Technical Bulletin

Product: AI Station Distribution: Internal and External Date: 12 December 2018

AI Stand Tablet Holder Bracket Replacement Kit Instructions

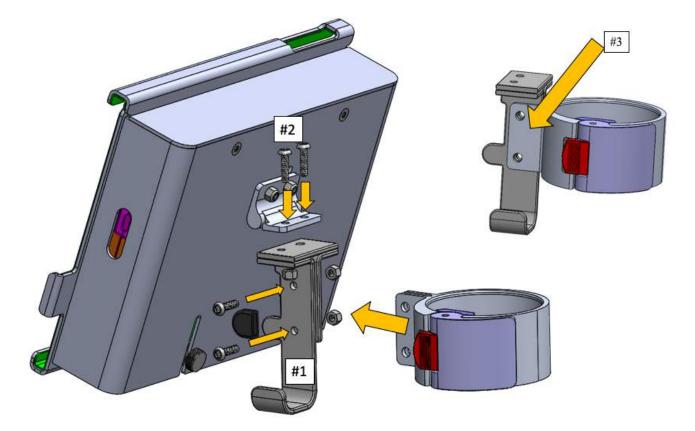
2. Replace the original Tablet Holder Bracket with the new Tablet Holder Bracket (#1). Replace the four (4) black oxide screws with the new tamper resistant screws in four (4) places shown below (#2). Reuse the Nyloc nuts that were removed.

Note: The flange should be on the outside of the bracket, on the "J" side (#3).

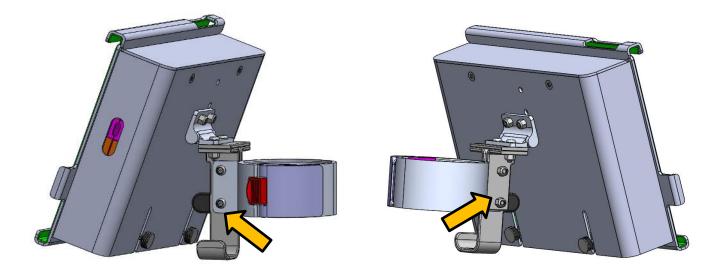
3. The completed replacement of the Tablet Holder Bracket is shown below. Note the orientation of the bracket and sleeve flange.
